# SERVICE BULLETIN

MODEL NAME : Di620
MODEL CODE : 1155
NO. : 028E
DATE : 990304
SUBJECT : COUNTERMEASURE FOR BLACK STREAKS WHEN EDH IS USED

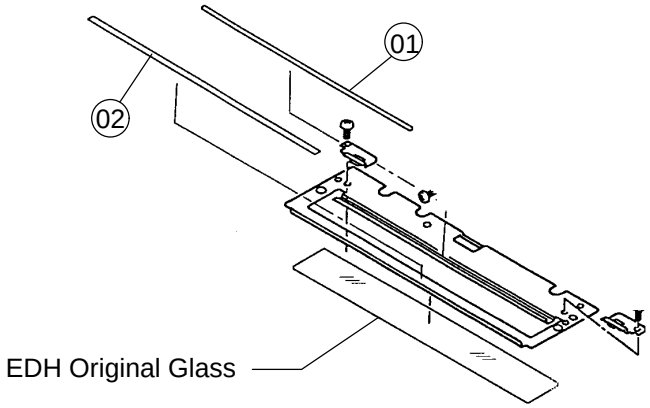
PROBLEM: There is a possibility that black streaks in the feeding direction may occur on copies when the EDH is being used.
CAUSE: Dust sticks to the inner side of the EDH original glass.
SOLUTION: To prevent dust from entering, a sponge (01) and polyester film (02) have been newly made.

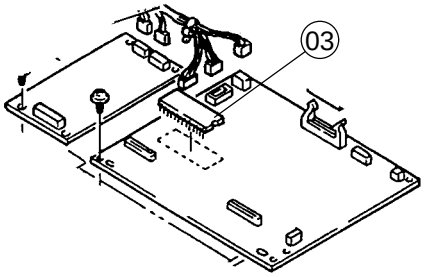
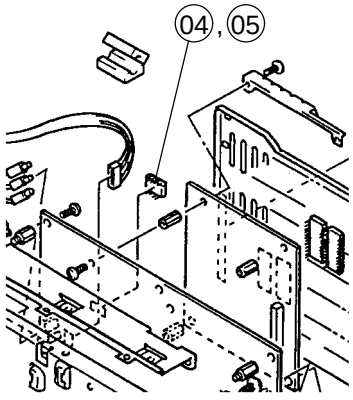
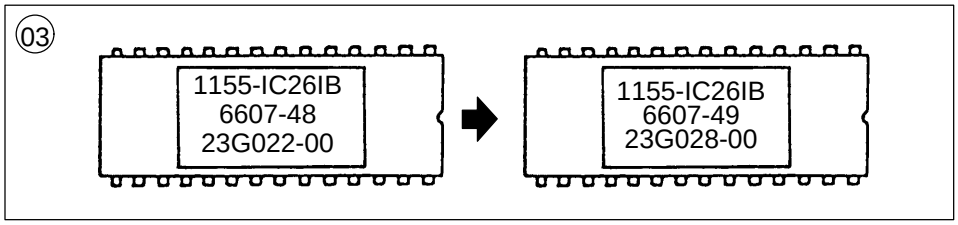
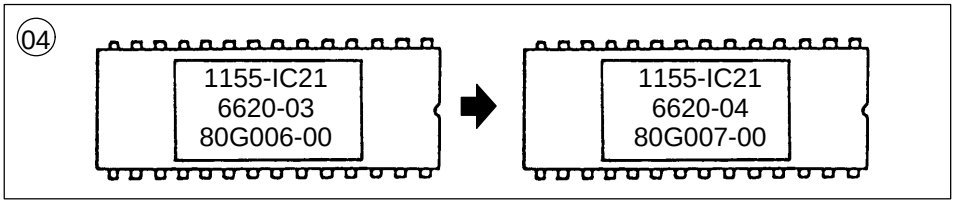
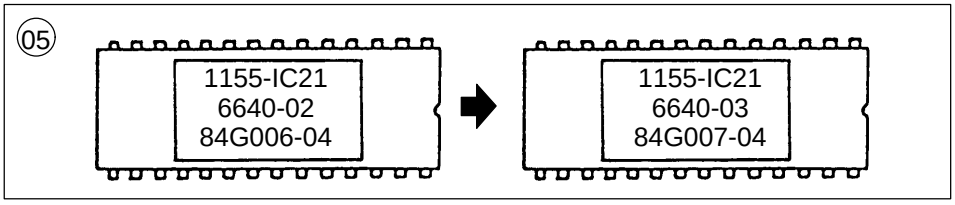
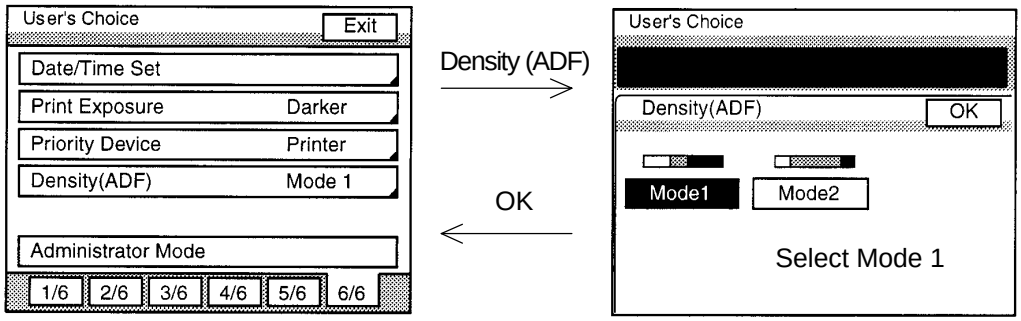
In connection with this change, the software program for IC26IB (03) on PWB-IB, IC21B (04, 05) and IC70B (06) have been changed to add a new function of “Density (ADF)” to p. 6/6 of the User’s Choice screen. (This function is valid only when the EDH is used and not when the original is placed manually.)

When Mode 1 is selected, the copier uses a gradation curve that cancels out low image density areas, which effectively prevents black streaks from occurring even when tiny dust particles stick to the EDH original glass.

Select the appropriate mode according to the need as detailed below:
1) Using ordinary originals (such as printouts from a word processor): Select mode 1.
2) To ensure better reproduction of faint originals: Select mode 2.

MODE 1: The copier uses a gradation curve that cancels out black streaks. (Default)
MODE 2: The copier uses the ordinary gradation curve.

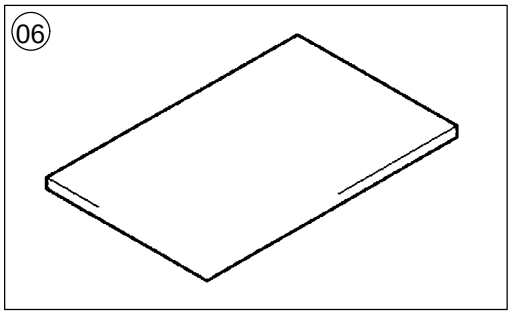
NOTE 1: The memory program for the memory card IC (06) has been changed as a result of the change made for IC70B.

IC70B VERSION: 10G0-37-00 ➡ 10G0-44-00

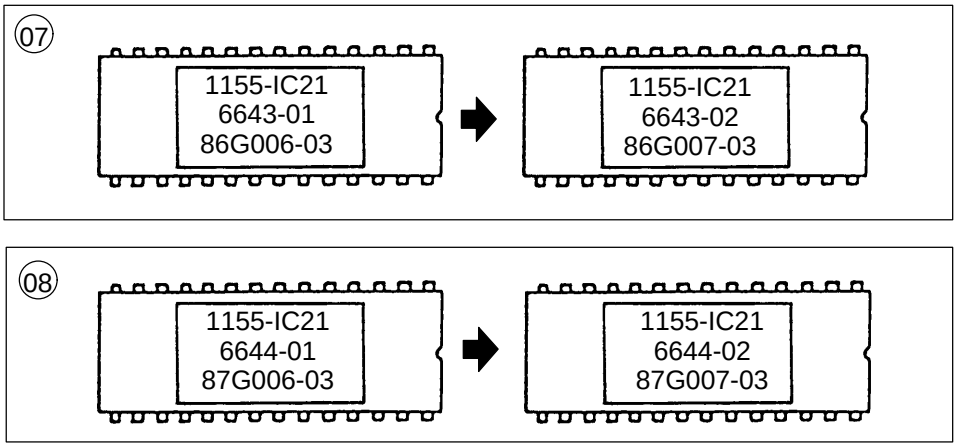
NOTE 2: The software program for the language ROM (07, 08) has also been changed in the same way as for IC21B (04, 05) .

NOTE 3: The new IC26IB (03) and IC21B (04, 05, 07 or 08) must be installed as a set in premodification machines, and have data rewritten using the new memory card IC (06).
